Nelson Service Center City of Spokane

Design Review - Recommendation Submittal
2515 E. Mallon Ave. Spokane, WA 99202

Nelson Service Center
City of Spokane
Design Review Board Recommendation Meeting Submittal
Written Project Summary - March 19, 2014

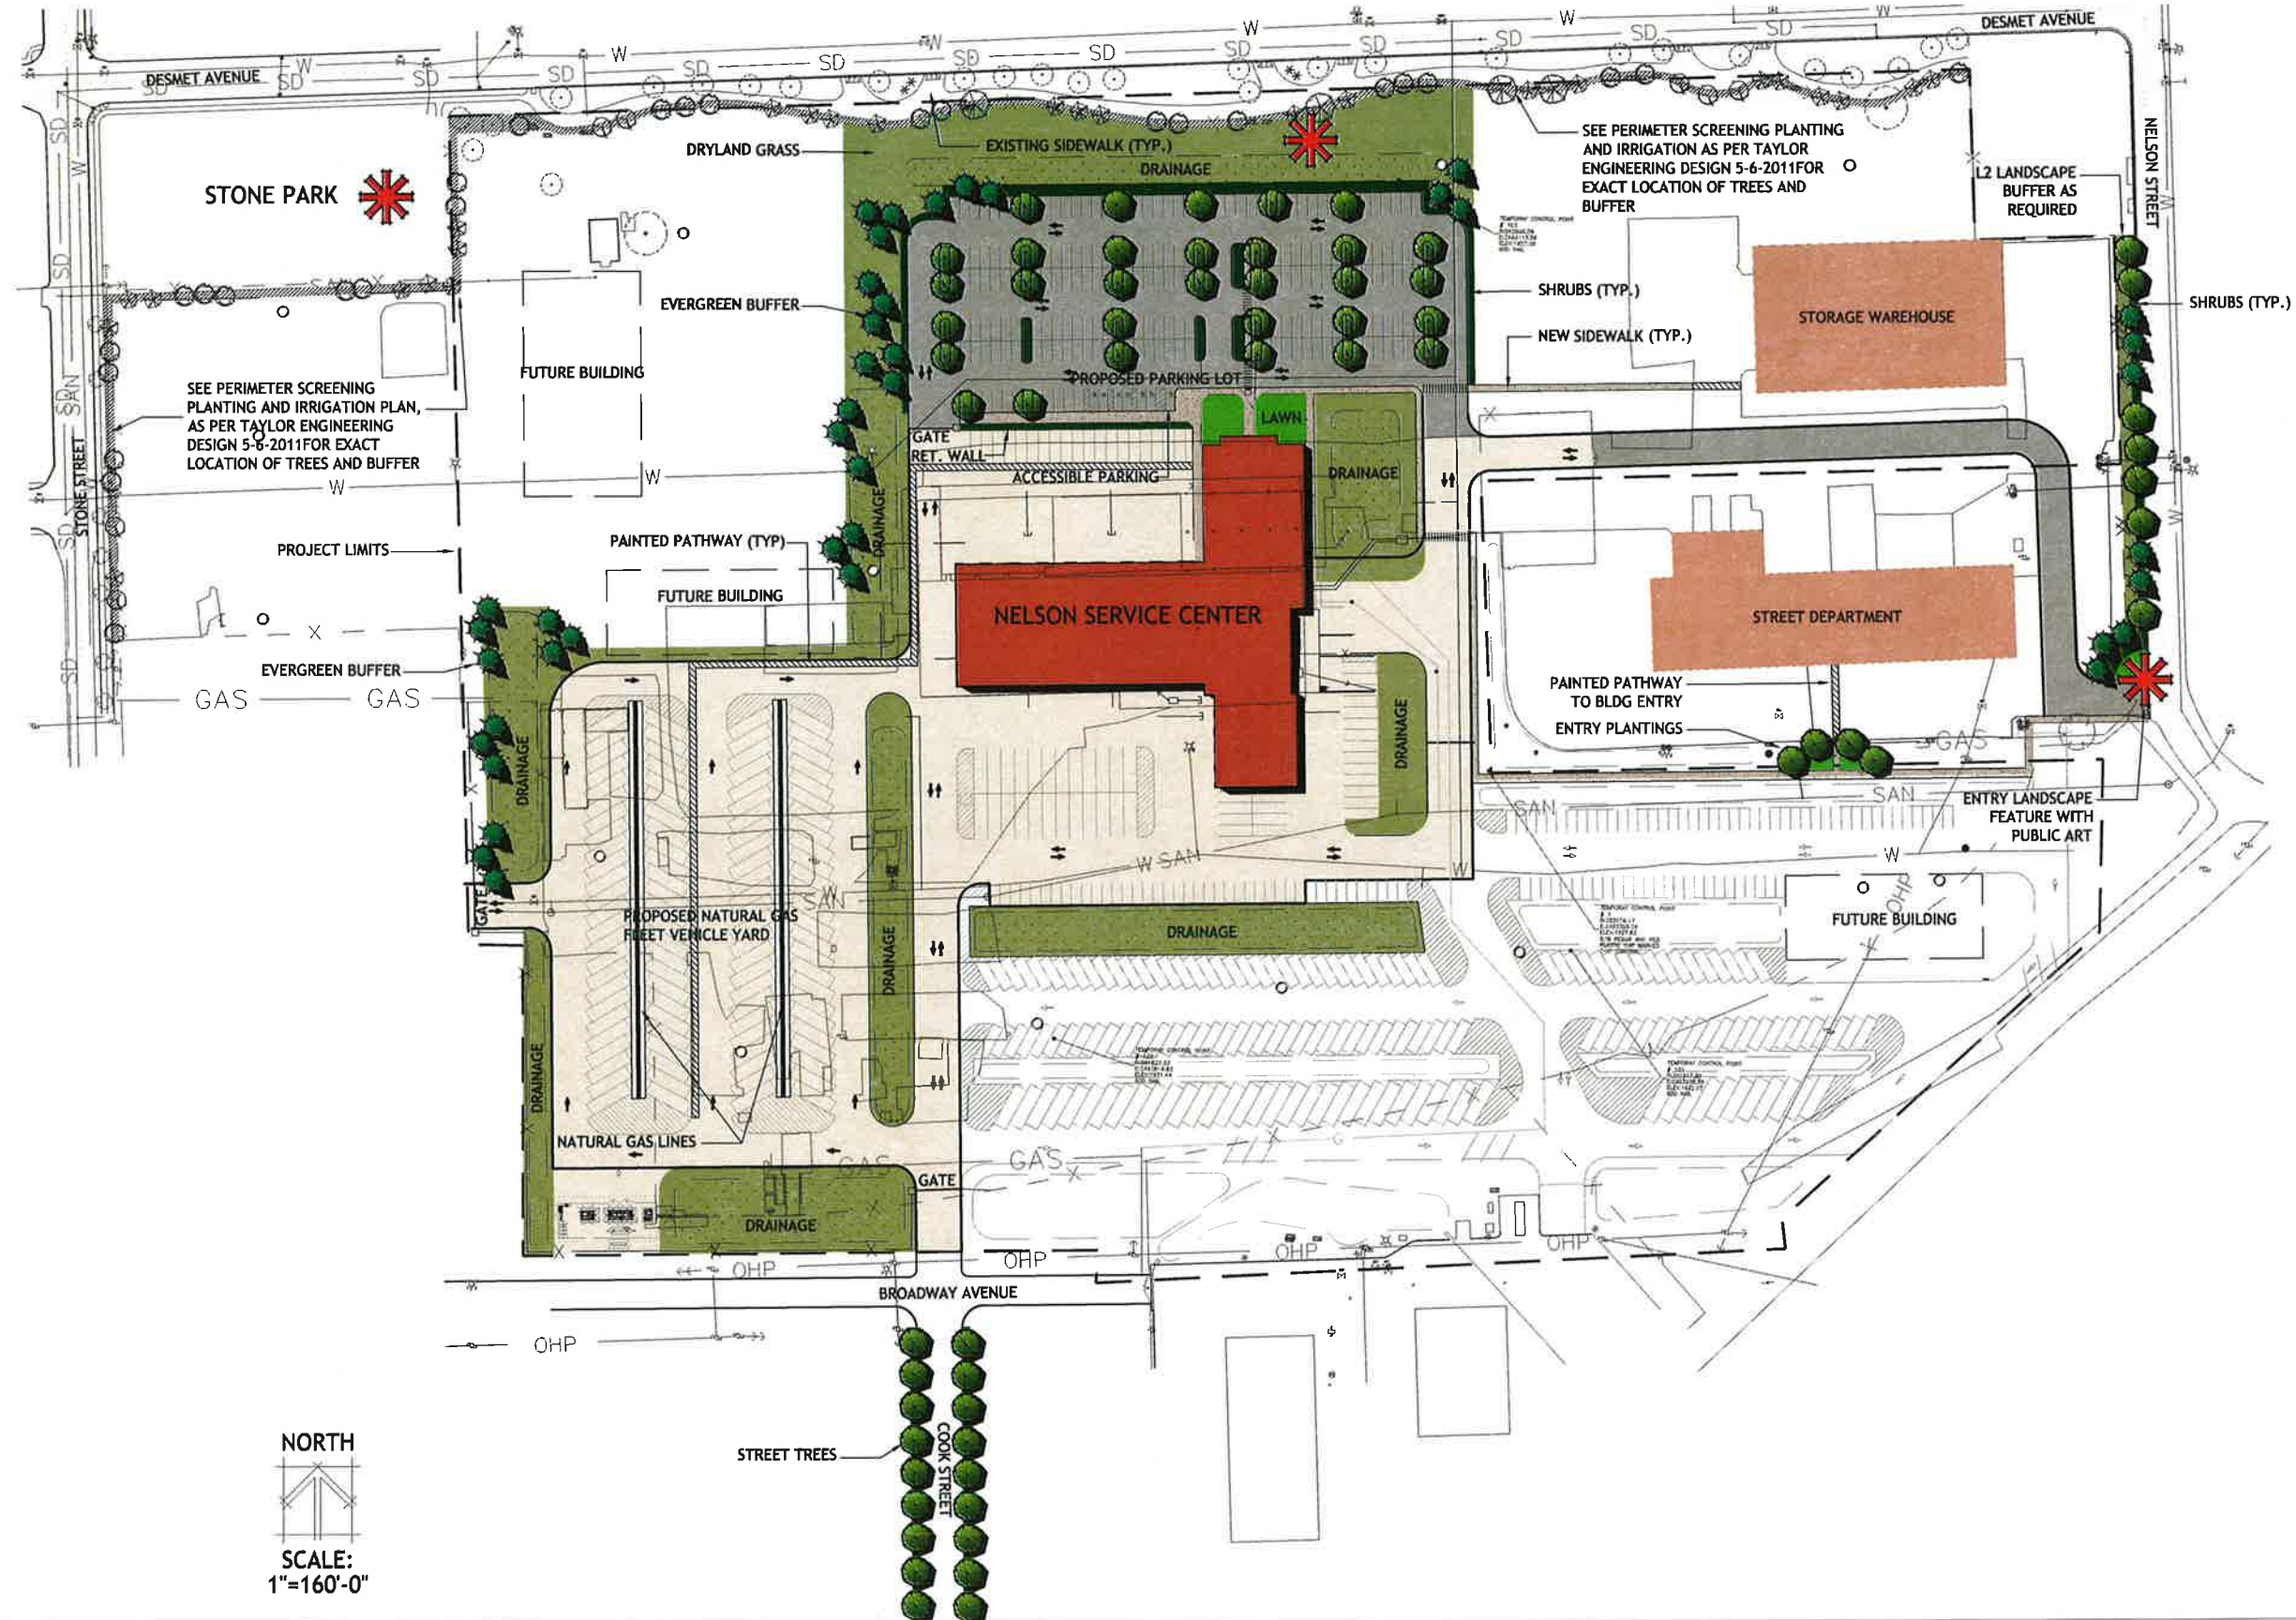
4. Explore design options that will enhance the northern elevations and screen wall façade to obtain a higher standard of design per the staff comments.

The City has enhanced the building's exterior appearance, focusing on the north façade of the building. In compliance with SMC 17C.130.515, the City has better emphasized the base, middle, and top of the building--a strategy that is intended reduce the apparent bulk of a building.

The building's rooflines are purposely articulated by stepping from a one-story building in the front to a two-story building behind. Walls are staggered and offset, and entries are recessed.

Additionally, the building will have a concrete masonry base, along with two tones of insulated metal panels to further visually separate the middle and upper sections of the building. A lighter color will be placed in the middle with a darker tone from the roofline to the top of the upper windows. The City will select between two color options--featuring two tones of silver or a brown/tan option.

Finally, the City also has added a five-foot planting bed in front of the screening wall to soften the transition between the wall and the sidewalk and further enhance the north façade.
